MANDATORY BULLETIN

MB No.: L23 / 050a REVISION No. 2

All L23 Super-Blanik sailplane.

Check of the control bridge at the place of gripping of control levers in the front and rear cockpit to exclude presence of eventual cracks.

Pic.No. 1

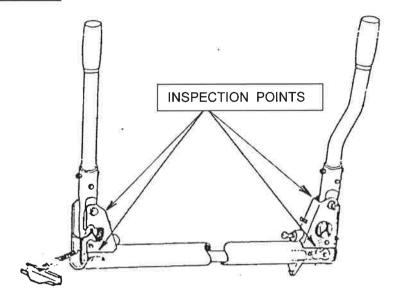
- 1. Dismantle the covers of both front and rear lever ...
- 2. Inspect visually by means of 6x zoom magnifier the bedding of front and rear control lever on the control bridge Dwg. No. A740 370N (or old design A741 210N if installed) at the places around welds and bends (according to pic.1 on both sides of the bridge) for presence of cracks.

Lighten up inspected the places properly. For visually inspection deflect gradually the control lever to the right side endstop (minimum aileron deflection) and still press on the control lever handle to the right with moderate pressure 40 ± 10 N up to the endstop - inspect the relevant part of the bridge, at which springing it causes sharpening of eventual cracks. By the same method carry out inspection at left deflection of control lever. Crack incidence is not allowed. Carry out checks at designated places of the control bridge at control levers in front and rear cockpit.

- 4. In a case that bedding is in good order carry out record into the Sailplane logbook according to the point H and continue in operation according to the relevant operation conditions for specified sailplane.
- 5. In a case that some cracks in a bedding have been found, it is necessary to carry out replacement of defected bedding Dwg.No. A740 371N in control bridge assembly Dwg. No. A740 370 N before continuing sailplane operation.
 Carry out replacement according to the Maintenance Manual L23 SUPER-BLANIK.
 Before replacement remove 2 pcs of bearings from the original Bearing A740371N according to the procedure in Apendix No.1. of the bulletin and install them into the new bedding, provided they are in a good condition.

1 pc - Beding Dwg.No. A740 371N - according to the result of inspection

2 pcs - Bearing 608 CSN 024630 - according to the result of inspection
